PLANNING, ZONING, & BUILDING DEPARTMENT
PZ&B Staff Combination Memorandum: Architectural Commission and Town Council

SUBJECT: ARC-23-044 (ZON-23-043) | 1480 N OCEAN BLVD

MEETING: MAY 29, 2024 ARCOM

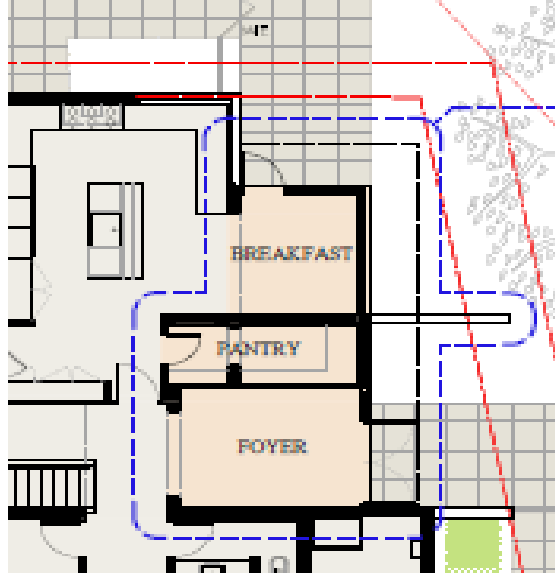
The existing layout and design of the home is unique to other single-family residences in the area. Designed in a modern architectural style, with white geometric forms and planes, the front entry has an accent wall that projects to reveal the front door and bisects it from a one-story glass geometric atrium interior dining space. The property has matured landscape hedges on the east and south. The area of work is not visible from the public right-of-way or adjacent neighbors.

Architecturally, the proposed changes simplify and coordinate that portion of the façade and remove a dated glass atrium element.

The structure is an existing nonconforming structure as it pertains to the cubic content ratio (CCR). The expansion of the covered entry area increases this nonconformity of CCR to 5.12. However, it is important to note that the actual expansion is just 107 SF of an covered areas and increased footprint. The lot coverage conversely is well under the maximum allowance of two-story structures by nearly 700 SF.
